Access Compliance Report Public Rights-of-Way (Curb Ramps)

Main Street: N_SHERI_ST Cross Street: BIXBY_AVE Location: NW

ADA ID: RPAT210924124238 Ramp Type: Type 6 - Directional 1 Initial Pass/Fail: Fail Overall Compliance: No Severity Score: 5

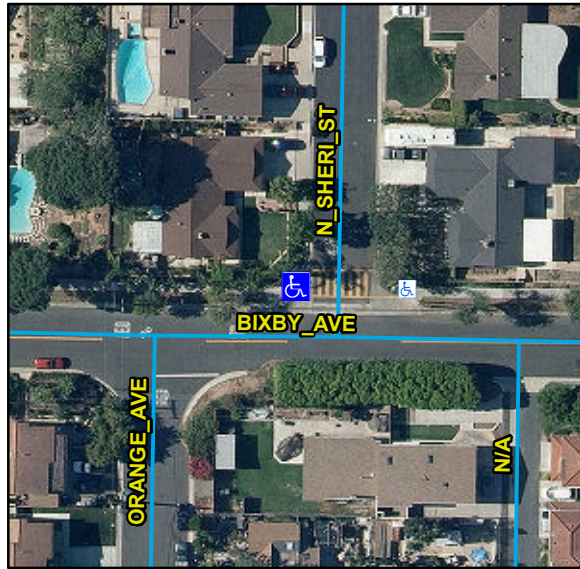
R304.5.1, R304.5.3, STD 1115

Remove & Replace Entire Ramp. Restripe Crosswalk.
